Project	IEEE 802.16 Broadband Wireless Access Working Group < http://ieee802.org/16 >
Title	PEAP Clarification
Date Submitted	2005-03-10
Source(s)	JUNHYUK SONG, JICHEOL LEE, YONG CHANG Voice: +82-31-279-3639 Samsung Electronics junhyuk.song@samsung.com
Re:	Re: IEEE P802.16e/D5a
Abstract	PEAP Clarification
Purpose	Discuss and Adopt as the baseline text
Notice	This document has been prepared to assist IEEE 802.16. It is offered as a basis for discussion and is not binding on the contributing individual(s) or organization(s). The material in this document is subject to change in form and content after further study. The contributor(s) reserve(s) the right to add, amend or withdraw material contained herein.
Release	The contributor grants a free, irrevocable license to the IEEE to incorporate material contained in this contribution, and any modifications thereof, in the creation of an IEEE Standards publication; to copyright in the IEEE's name any IEEE Standards publication even though it may include portions of this contribution; and at the IEEE's sole discretion to permit others to reproduce in whole or in part the resulting IEEE Standards publication. The contributor also acknowledg

Figure 133—AK with EAP only authentication

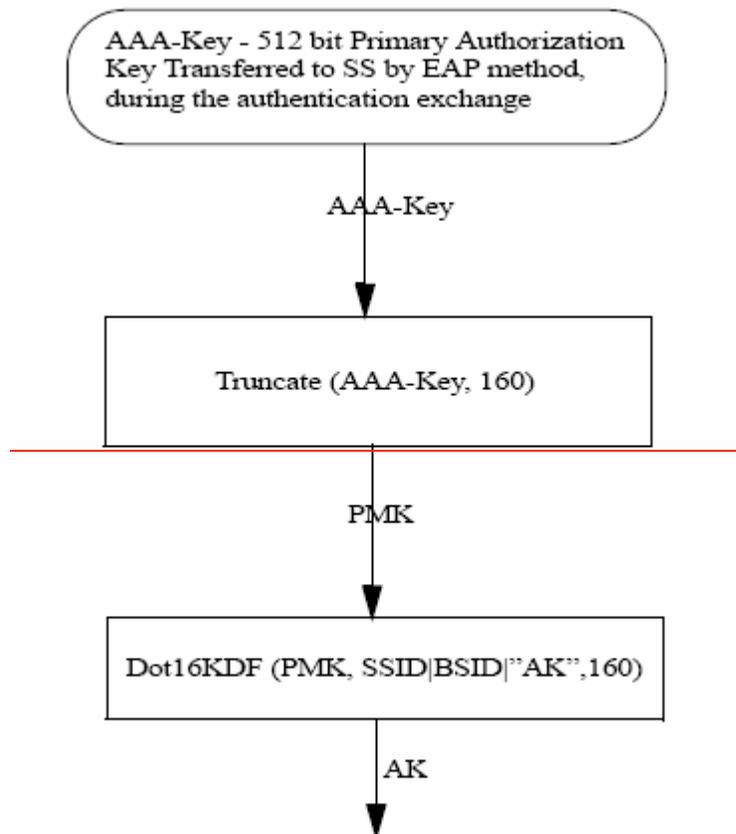
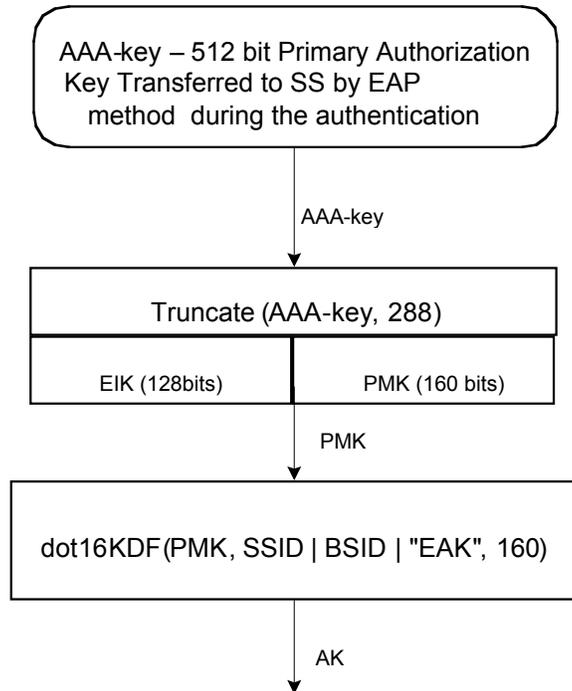
The product of the EAP exchange which is transferred to 802.16 layer is the AAA-key. This key is derived (or may be equivalent to the 512-bits Master Session Key (MSK)). This key is known to the AAA server, to the Authenticator* (transferred from AAA server) and to the MS. The MS and the authenticator derive a PMK (Pairwise Master Key) [and optional EIK](#) by truncating the AAA-key ~~after~~ [to 288+60](#) bits.

[EIK](#)|PMK = truncate (AAA-key, [288+60](#))

[Change Figure 133]
